REPLACEMENT THERMOSTAT COVER

THIS EFFECTS EARLY SHIRE ENGINES WITH BASE 3TNE BLOCKS

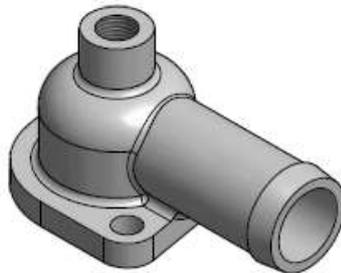
The original thermostat housing of RDG2579 is now no longer available and will need to be repaired/replaced by the below.

ORIGINAL COVER REPLACEMENT NLA: RDG2579

NEW STYLE COVER: RDG504A15

1. Repair the old one.
2. Get a new one made using the old one as a pattern
3. Due to the reorientation of the mounting holes you will need to fit the new housing (as above) and change/re-route the hoses on the boat to match the outlet position. Plus you will need the normal Yanmar gasket (129795-49551) and a ¼" BSP M/F elbow in the top to a ¼" BSP to 5/16" hose tail to fit the leak off hose to.
